Our ref: GE18103/LL01v2.0/200117
Your ref: LU/354/19/DOC

RE: Land South of Cornfield Close Littlehampton BN17 6LD- Approval of details reserved by condition imposed under ref LU/330/18/PL relating to Condition Nos 9 - periodic verification reports

Appendix A – Updated gas protection measure drawing details (Drawing refs: M637-60.25.01, M637-60.26.01, M637-60.50.03 & M637-60.50.04)

Party Wall/G.F. Slab Substructure Detail

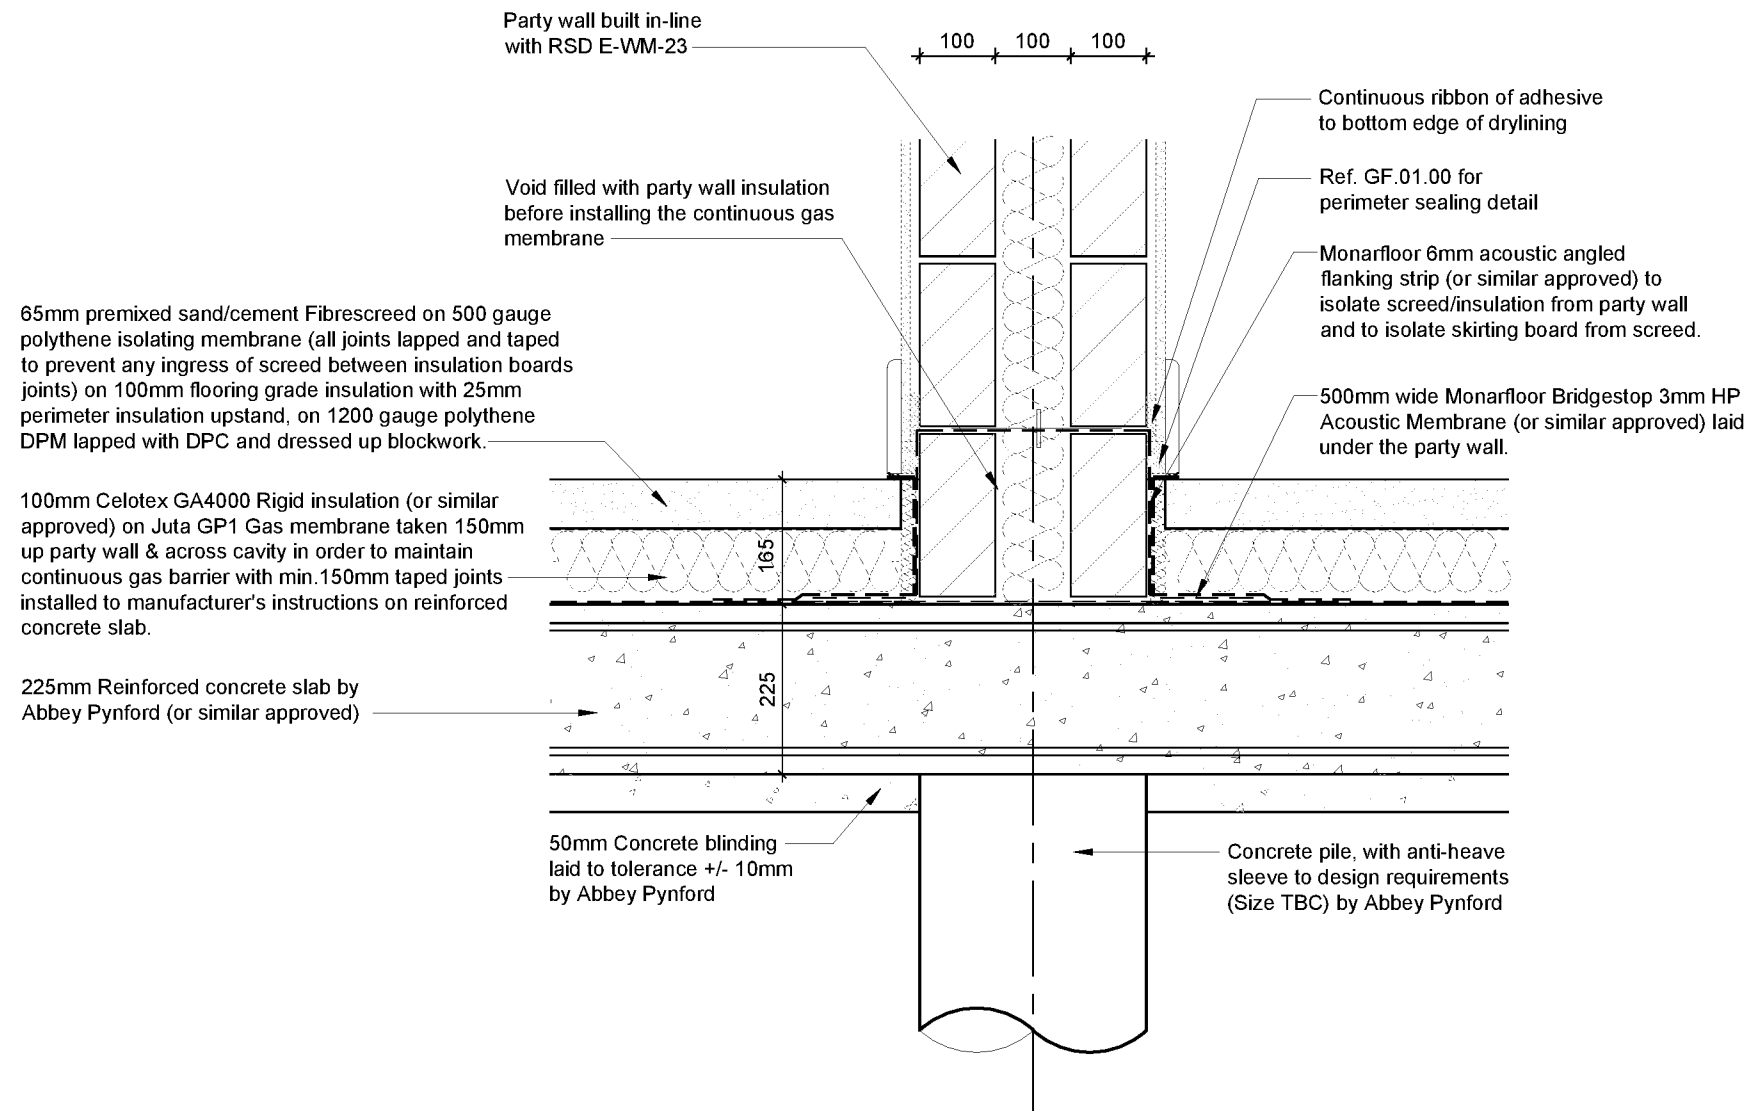
- 2) Furthermore, exceedances of methane, carbon dioxide, oxygen, carbon monoxide, hydrogen sulphate and VOCs were previously identified, however only methane and carbon dioxide concentrations are discussed -this should be clarified.**

C03	19.12.19	DETAIL UPDATED TO SUIT GAS MEMBRANE COMMENTS.	A/H	C
C02	09.10.19	SUB FLOOR VOID & VENTS COMMITTED & DPCS UPDATED.	A/H	C
C01	12.06.19	ISSUED FOR CONSTRUCTION	A/H	C
P02	07.03.19	225mm AIR VOID AND TELESCOPIC VENTS INTRODUCED.	A/H	C
P01	07.12.18	FIRST ISSUE	A/H	C
REV	DATE	DESCRIPTION	INITIAL	CHECK

We understand that it is proposed to utilise a Juta GP1 membrane as part of the development, GP1 is specifically designed and manufactured to perform as a Methane, Carbon Dioxide, Radon, Ground Gas, VOC, air & Moisture protection system, and therefore will provide a sufficient level of protection to the building and users from the elevated concentrations of gases (Methane and Carbon Dioxide) identified beneath the site.

It is understood that Thakeham Homes Limited have previously provided a copy of the plans for the gas protection measure details to the Council, however please find updated plans enclosed within Appendix A. The gas protection measures are to be installed and verified by Keytech with additional independent validation then also undertaken by Geo-Environmental.

Party Wall/G.F. Slab Substructure Detail

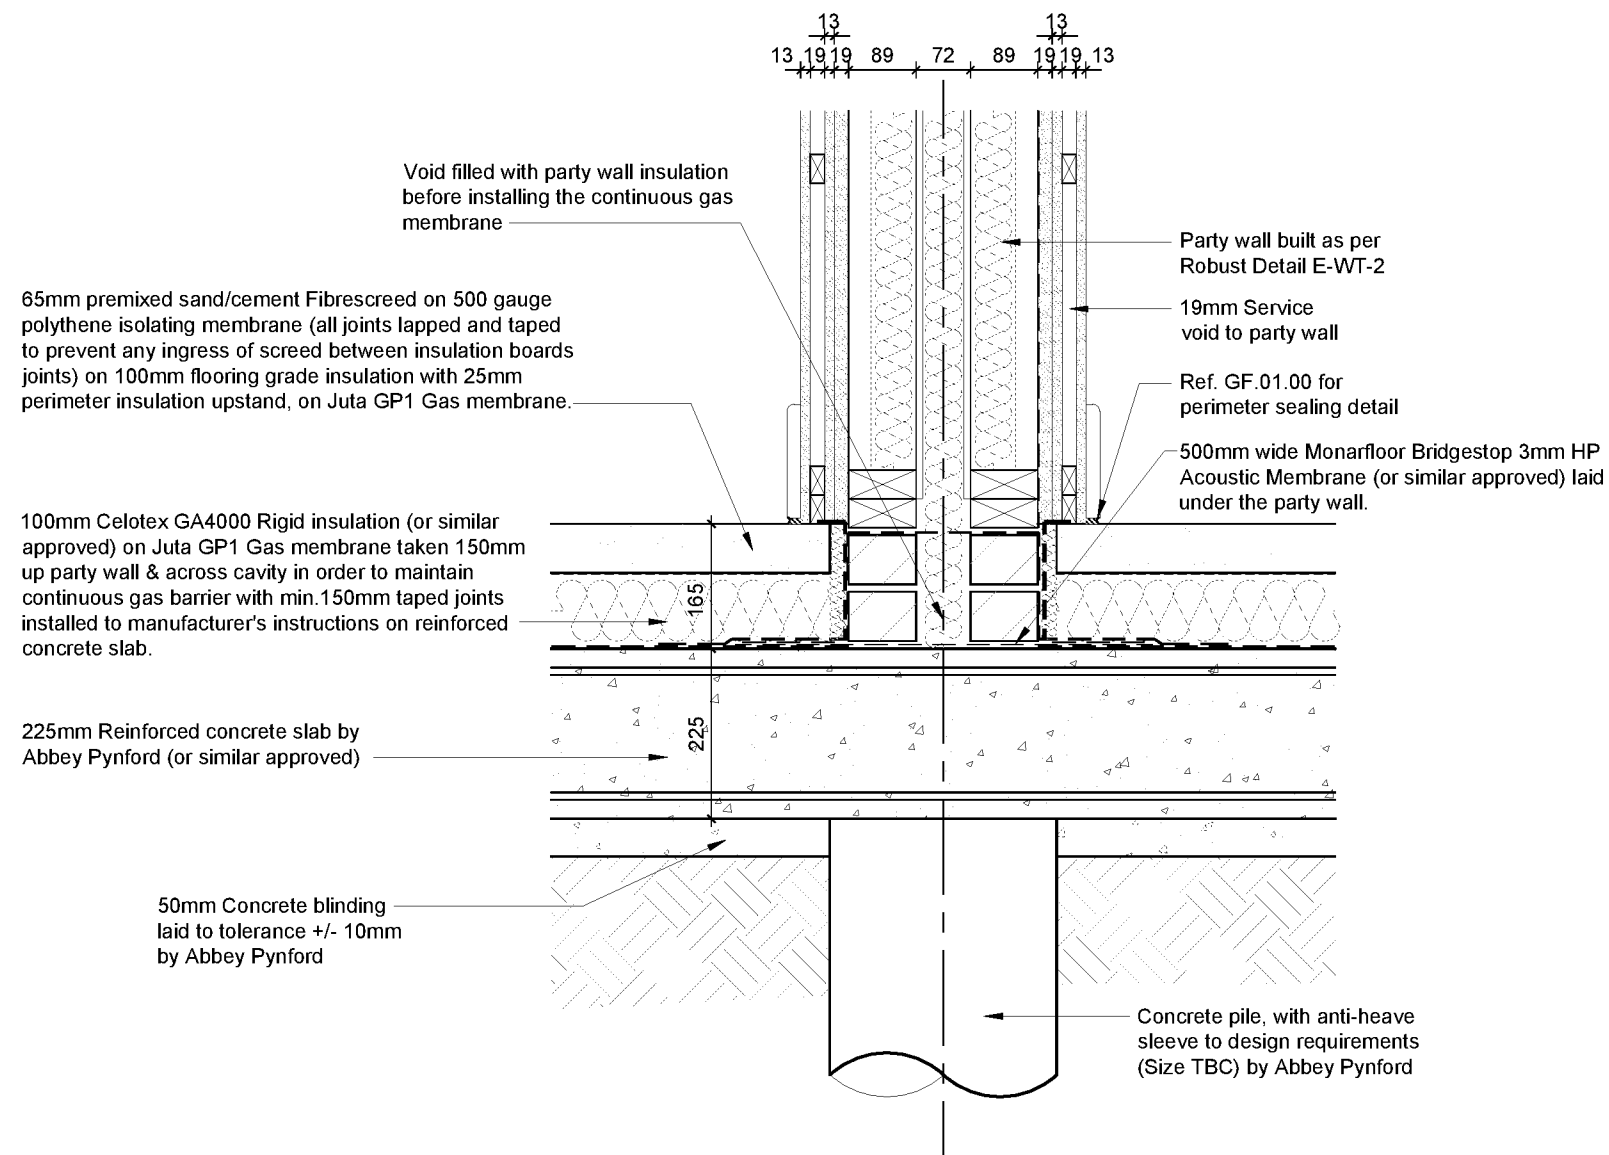
C03	19.12.19	DETAIL UPDATED TO SUIT GAS MEMBRANE COMMENTS.	A/H	C
C02	09.10.19	SUB FLOOR VOID & VENTS OMITTED, PARTY WALL DETAIL AMENDED.	A/H	C
C01	12.06.19	ISSUED FOR CONSTRUCTION	A/H	C
P02	07.03.19	225mm AIR VOID AND TELESCOPIC VENTS INTRODUCED.	A/H	C
P01	07.12.18	FIRST ISSUE	A/H	C
REV	DATE	DESCRIPTION	INITIAL	CHECK
